Name	[REDACTED] Further contact via my nephew, [REDACTED] who I authorise to respond on my behalf [REDACTED]
DA	SSD-10360337
Location	10 Lomas Lane and 210 Wine Country Drive, Nulkaba
Applicant	St Phillip's Christian Education Foundation Ltd
Statement	<b>Objection</b> to proposed construction of roundabout (Lomas Lane/Wine Country Drive)
Donations	I have not made a reportable political donation in the past two years.

Figure 1: 313 Wine Country Drive, Nulkaba – driveway access at intersection of Lomas Lane and Wine Country Drive

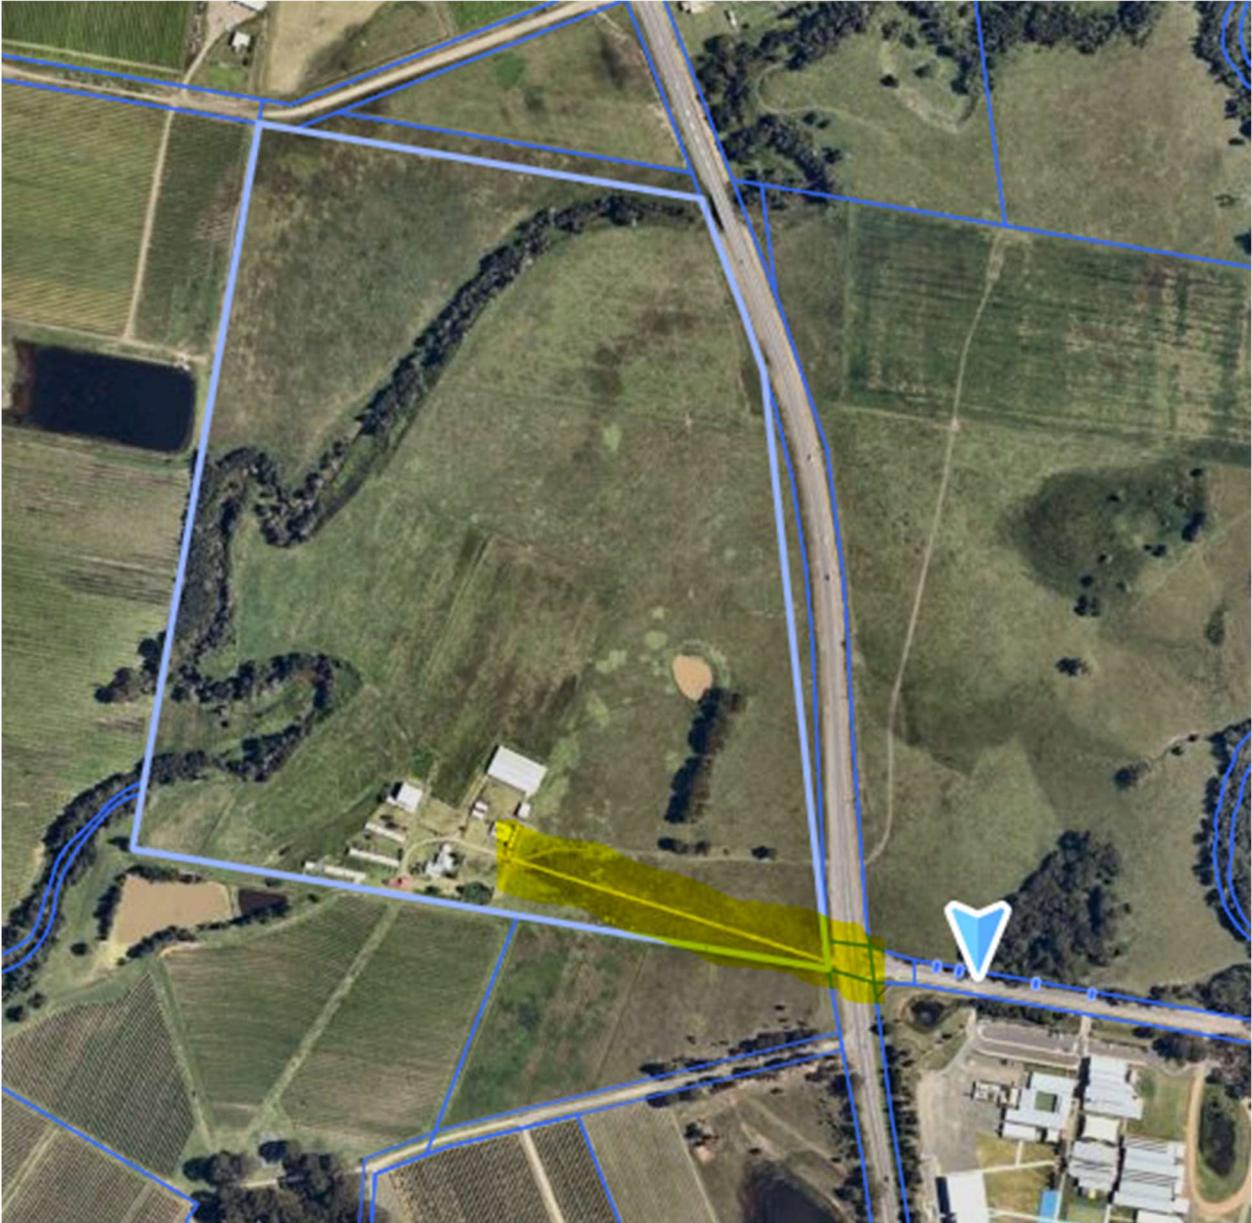
I am the owner of [REDACTED] Nulkaba [REDACTED] that is zoned RU4: Primary Production Small Lots. This is a family farm and I have continued to use this property for farming purposes for over 70 years. My property is accessed from a driveway located at the intersection of Lomas Lane and Wine Country Drive. My site requires truck access for transporting livestock. The current site configuration and driveway access is shown in Figure 1 (at the end of this submission) and highlighted in yellow.

Figure 2: Civil Engineering Plan Drawing Number DA-C06.01

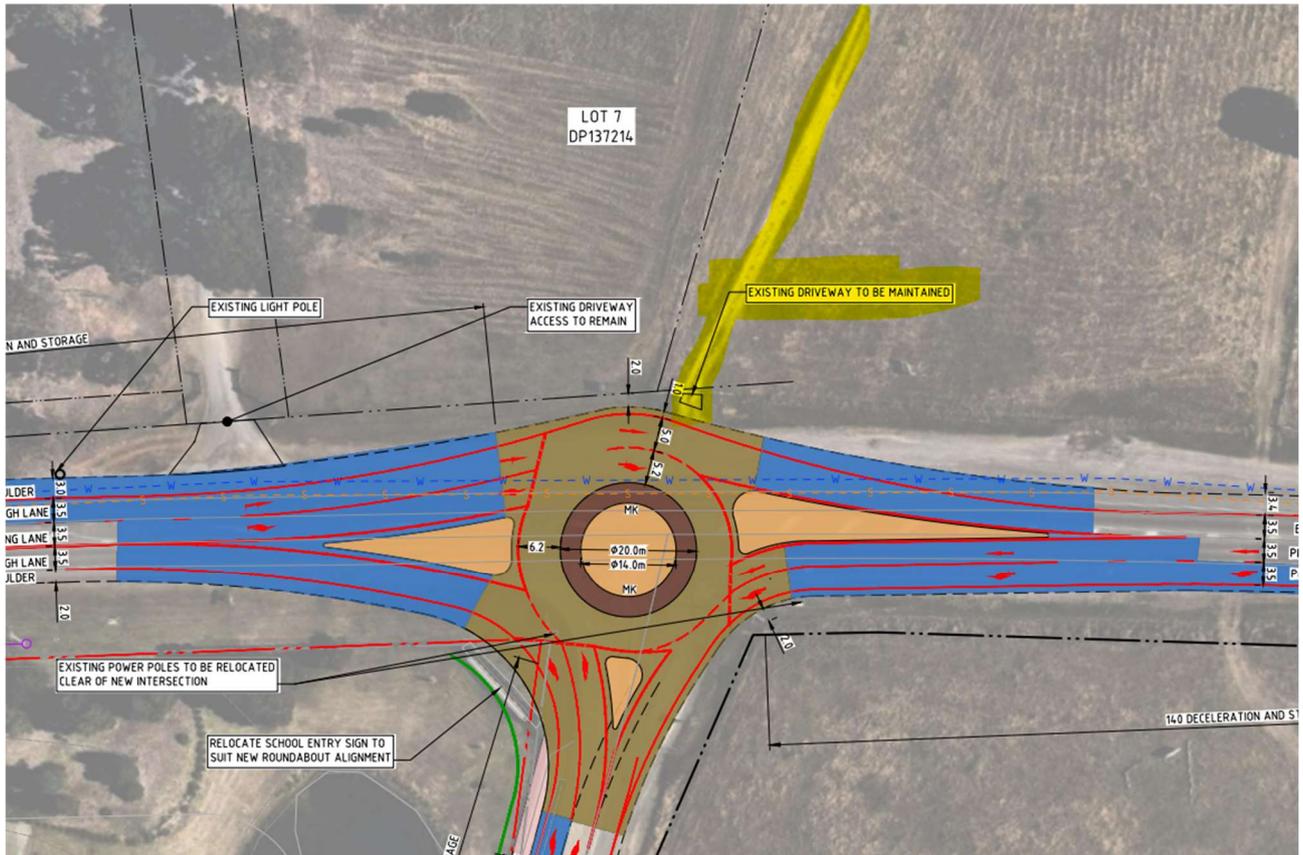
I have reviewed the civil engineering plans and understand that my existing driveway is to be retained as shown in Figure 2 with my driveway highlighted in yellow. This will have my driveway exiting directly into the path of the through-travel lane of the proposed roundabout.

The proposed roundabout is two lanes with my entry being located off the through-travel lane. There is serious risk of collision given that vehicles will need to slow to enter the driveway, but as this is not a formalised exit, it will not be expected. This lack of a formalised 'leg' will create difficulty in entering the roundabout as it will lead into the through-travel lane which may be traveling at greater speed.

Given that my driveway is located in the centre of the roundabout it provides no 'distance to intersection' and will result in 'possible confusion' within the intersection. This will be particularly caused by the unexpected deceleration movement to enter the driveway and also the slower entry speed into the roundabout when exiting the property.

As the current design does not treat my driveway as a formalised 'leg' of the roundabout, it fails to meet the roundabout design principles.

My driveway is shown only as 'to be retained' in Appendix G: Concept Intersection Designs (page 173). I note that the drawing provided is in fact the same civil engineering drawing from G4 *Concept Civil Engineering Plans* as both documents produce the same plan noted as Drawing Number DA-C06.01.

The report contains no discussion about my existing driveway or the proposal to retain it. It is only the plan that shows the retention. I am of the view that the applicant has failed to adequately consider the existing site conditions and plan accordingly.
